Attachment G
Exceptions to Design Standards

Fact Sheet Exceptions to Mandatory Design Standards

LAUREN PROCTOR, Registered Civil Engineer
CH2M HILL

**MANDATORY EXCEPTION NO.1B
 SUPERELEVATION = 5%, LESS
 THAN 12% STANDARD SUPERELEVATION**

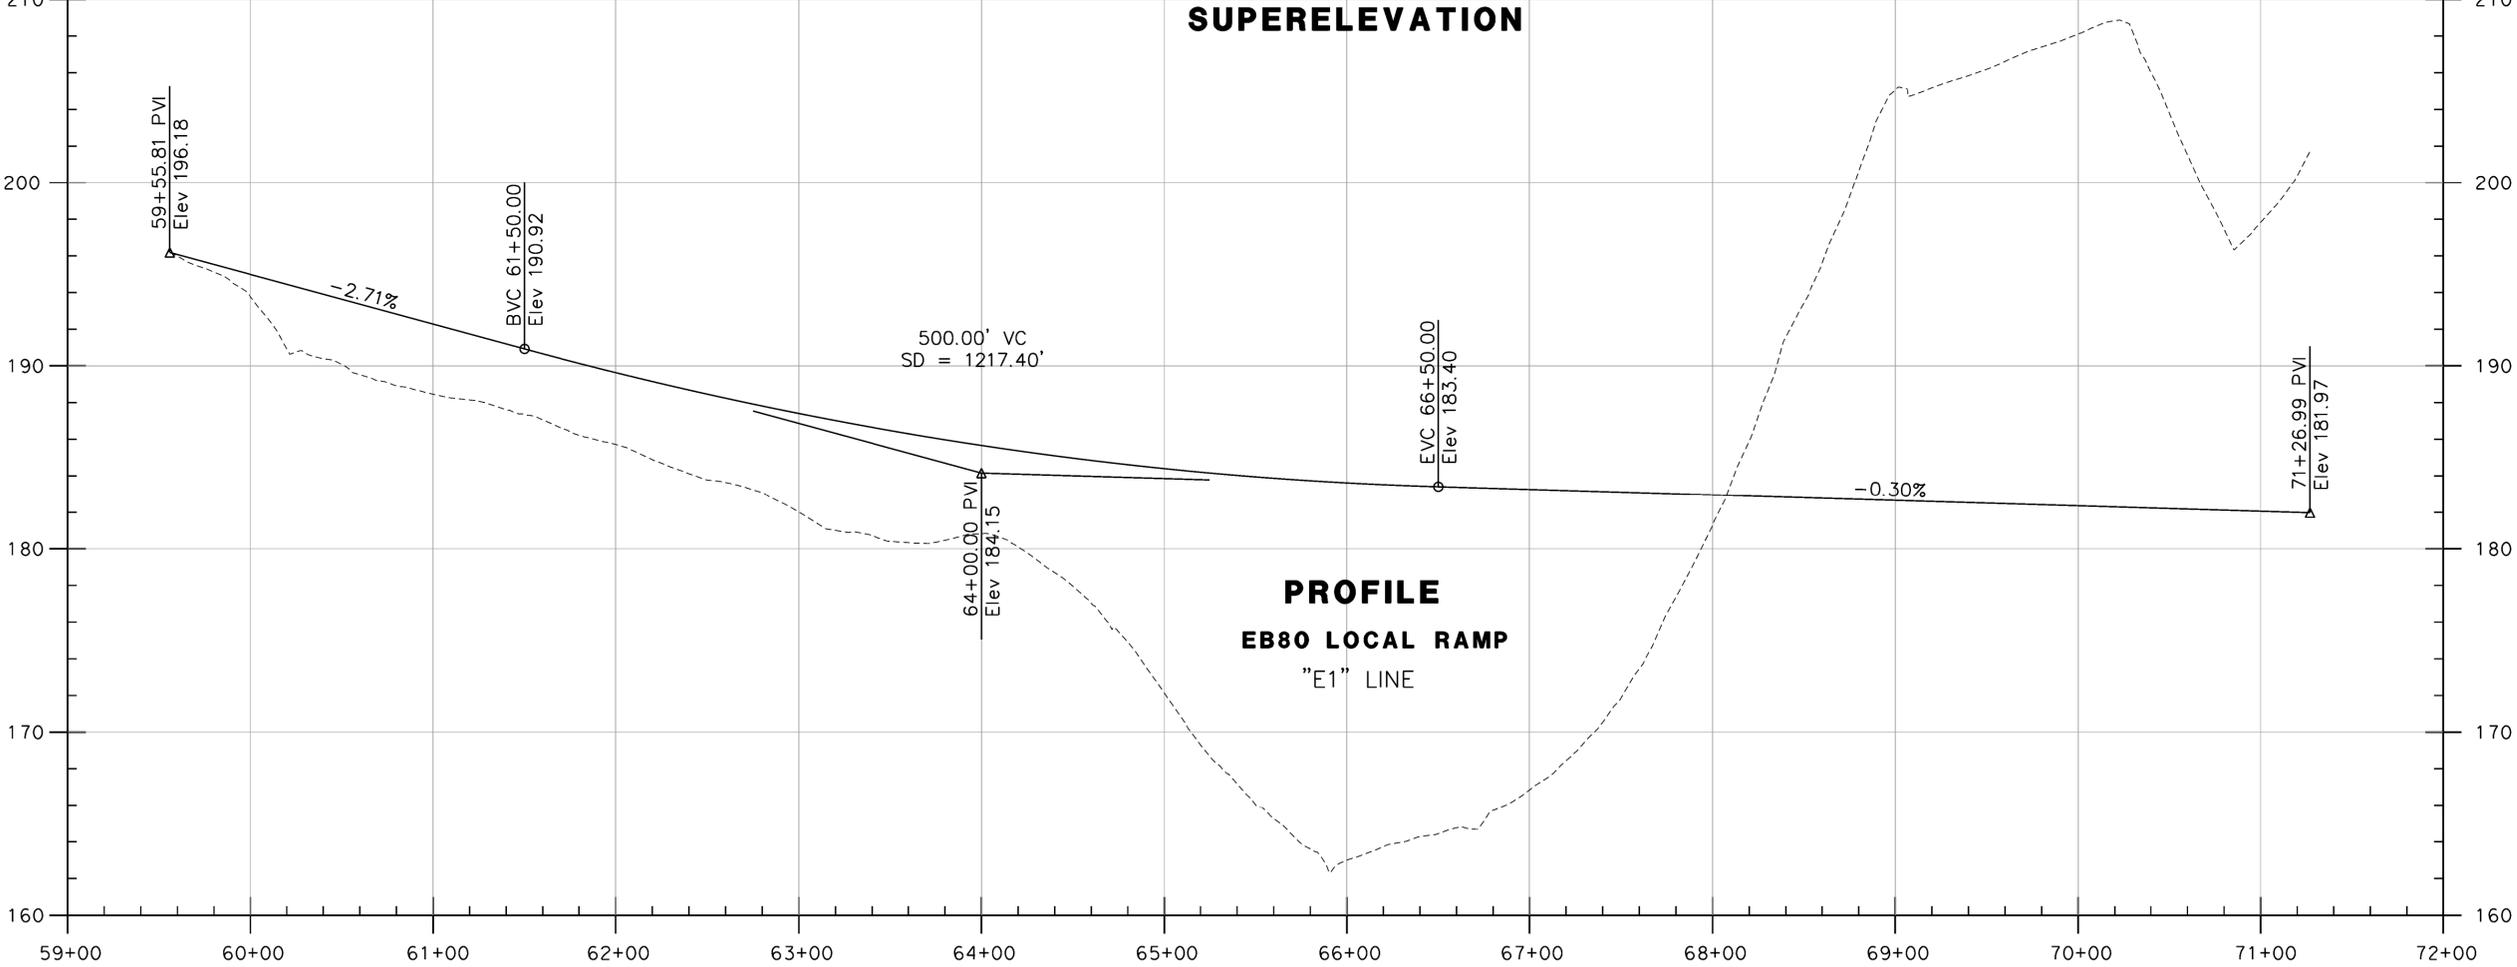
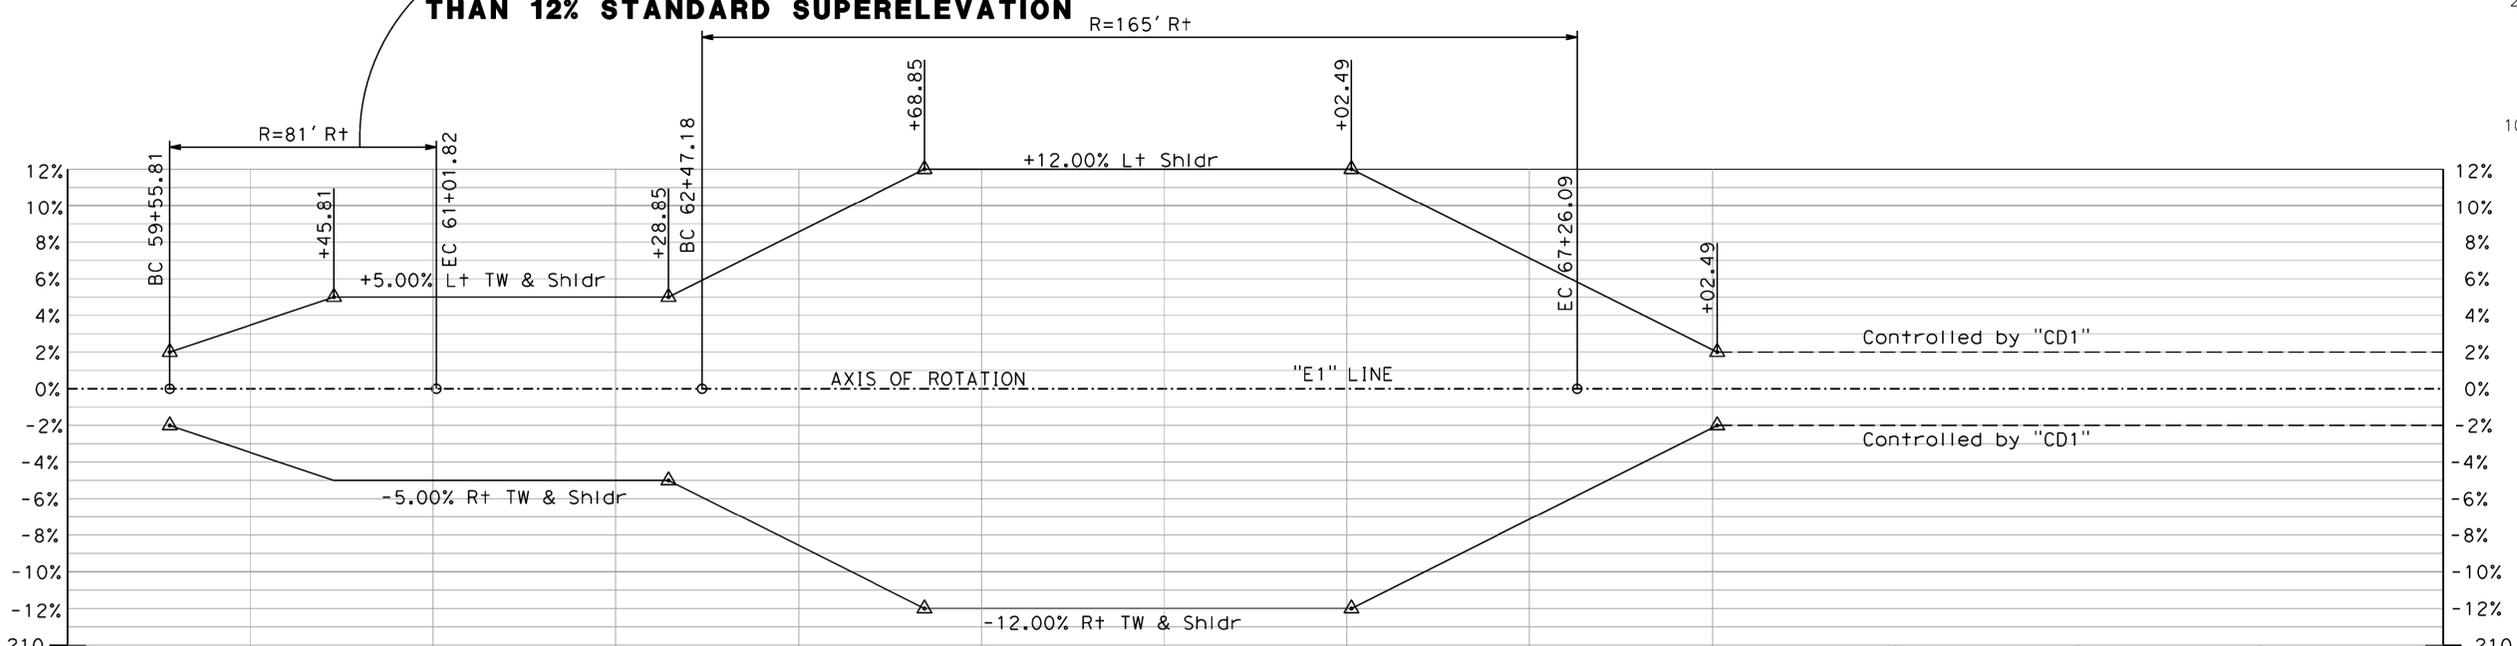
Location B: Eureka EB Loop on-ramp, “E1” station 59+55.81 to 61+01.82, the proposed 81' curve will have superelevation rate of 5%. (See Attachment 3)

The standard superelevation required for 81' curve is 12%.

Location B: The reason for the design exception for location B is due to the ADA requirement for pedestrian crossing with a gradient no greater than 5%. A higher superelevation rate would require an alignment with a longer tangent to accommodate pedestrian crossing where the slope is less than 5%, which would shift the alignment further to the south and impact Eureka Rd/Taylor Rd intersection.

Conformance to standard would require relocating the Eureka Rd/Taylor Rd intersection to the south, realigning the EB off-ramp, impacting an environmental sensitive area, and acquiring new right of way.

ATTACHMENT 4

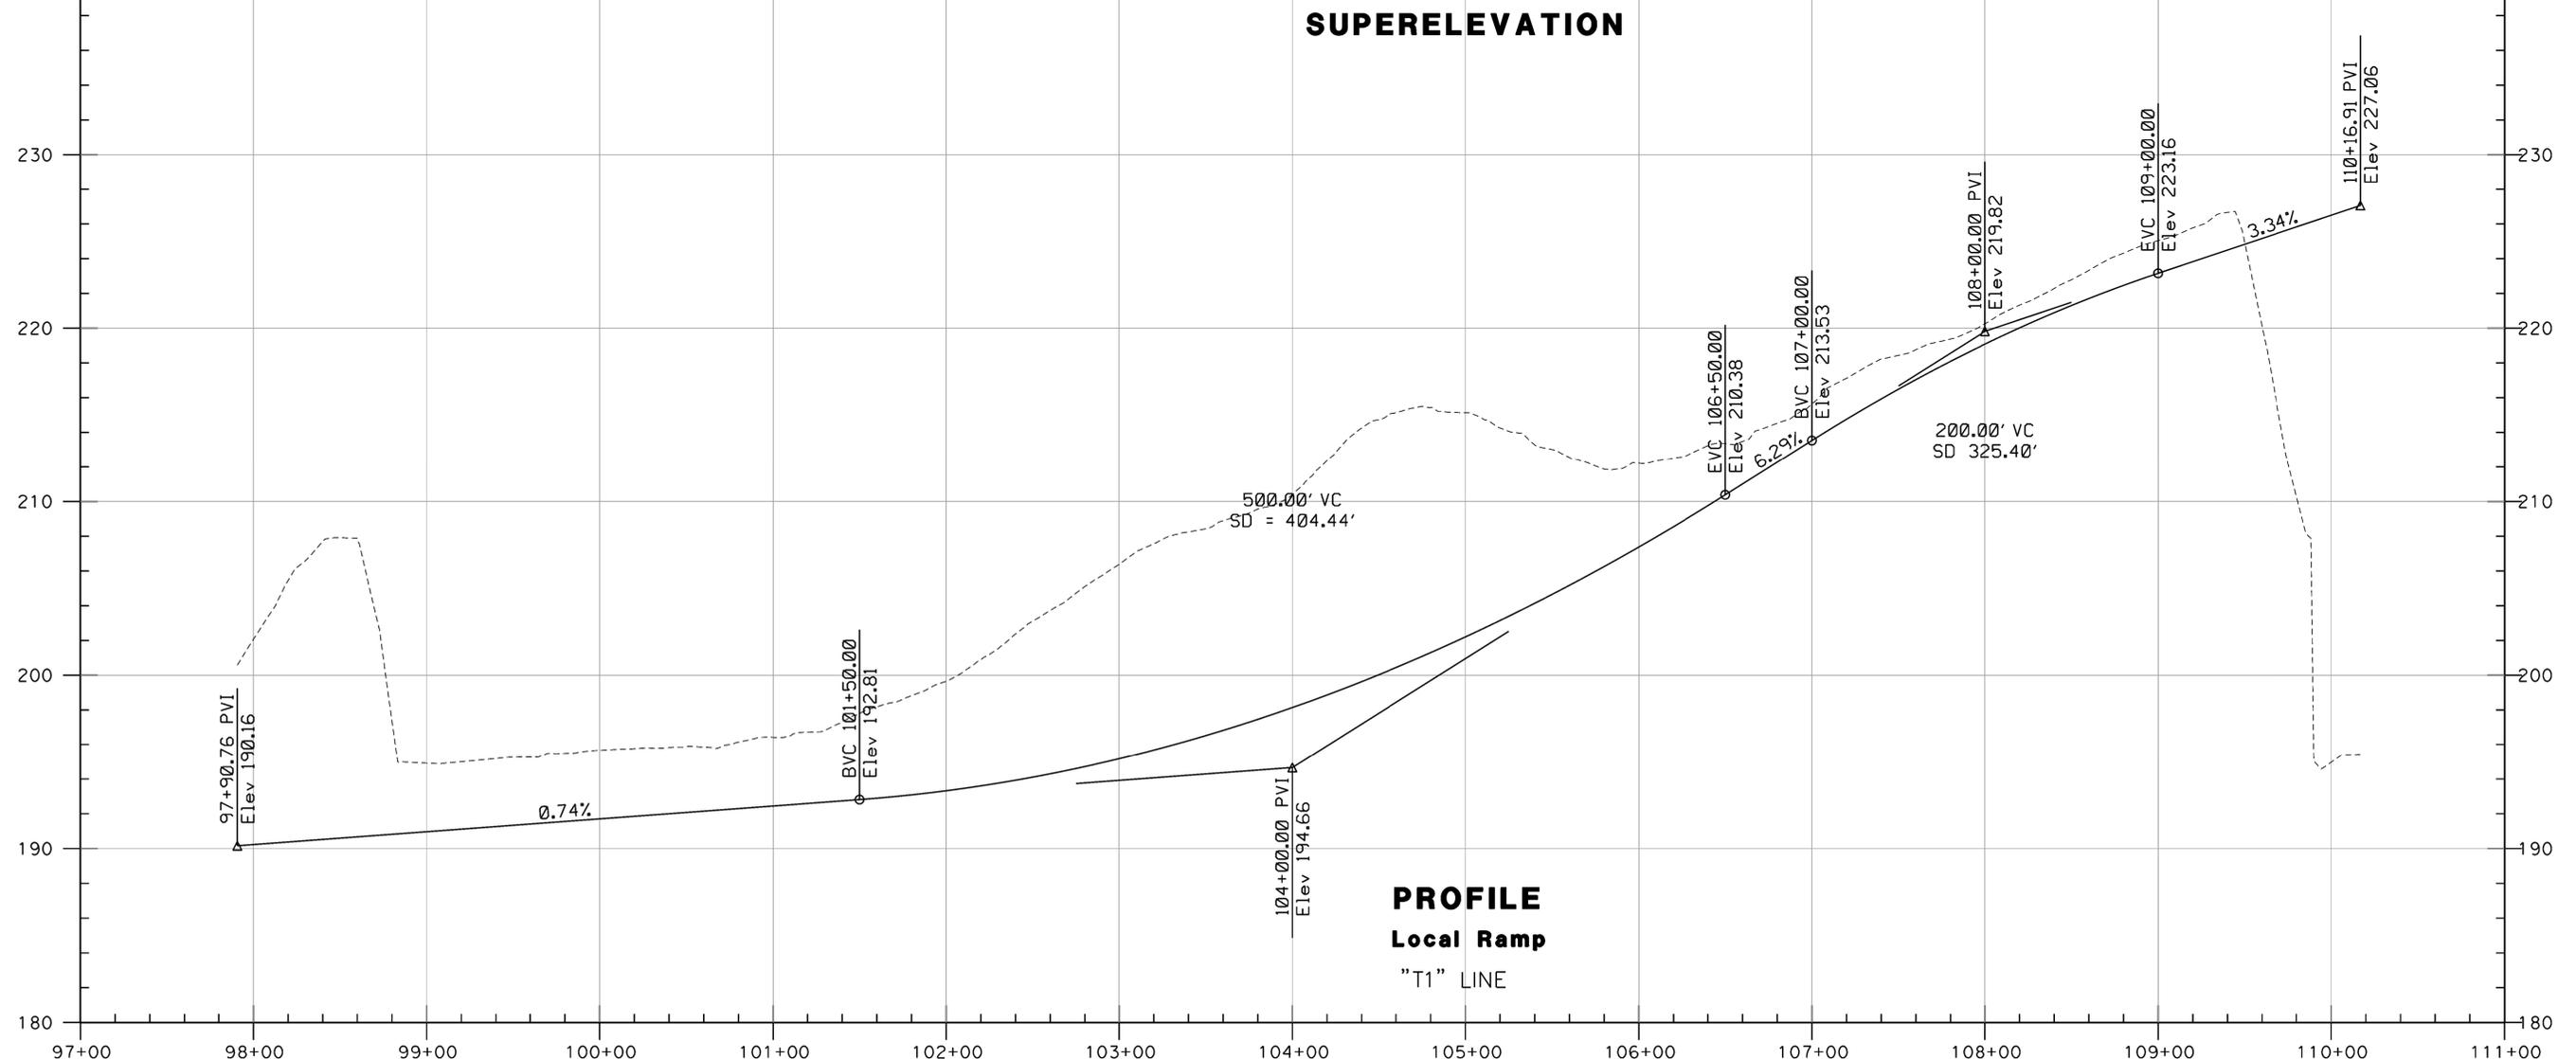
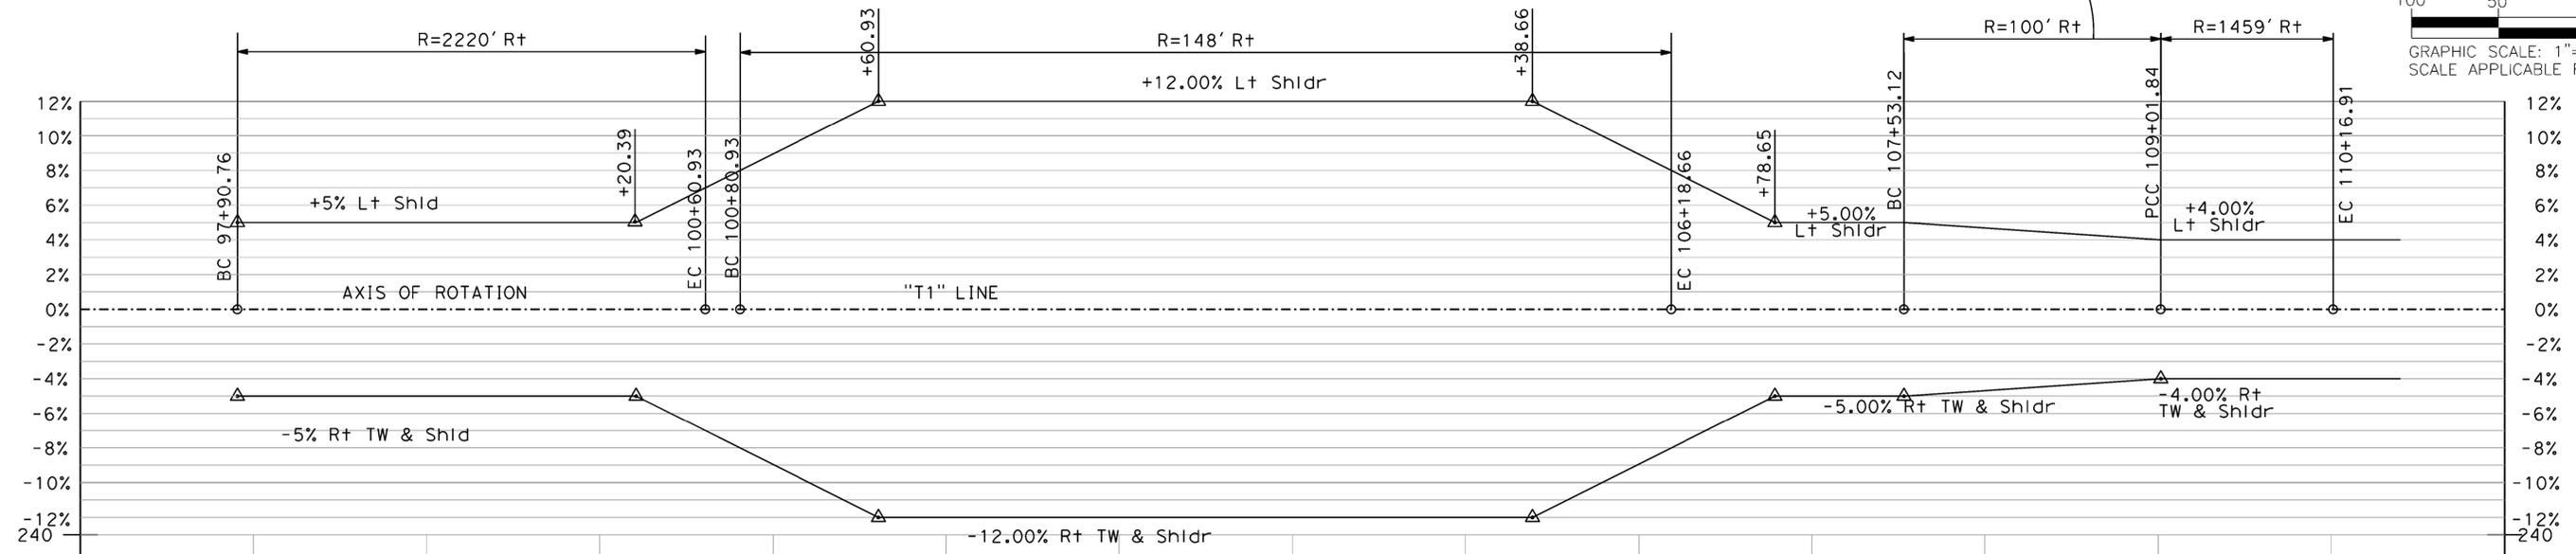
Location C: Taylor EB Loop off-ramp, “T1” station 107+53.03 to 109+01.46, the proposed 100' curve will have superelevation rate of 5%. (See Attachment 4)

The standard superelevation required for 100' curve is 12%.

**MANDATORY EXCEPTION NO.1C
SUPERELEVATION = 5%, LESS
THAN 12% STANDARD SUPERELEVATION**

Location C: The reason for the design exception for location C is due to the ADA requirement for pedestrian crossing with a gradient no greater than 5%. A higher superelevation rate would require an alignment with a longer tangent to accommodate pedestrian crossing where the slope is less than 5%, which would shift the alignment further to the south and impact Residence Inn hotel.

Conformance to standard would require acquiring right of way where an existing hotel is located.
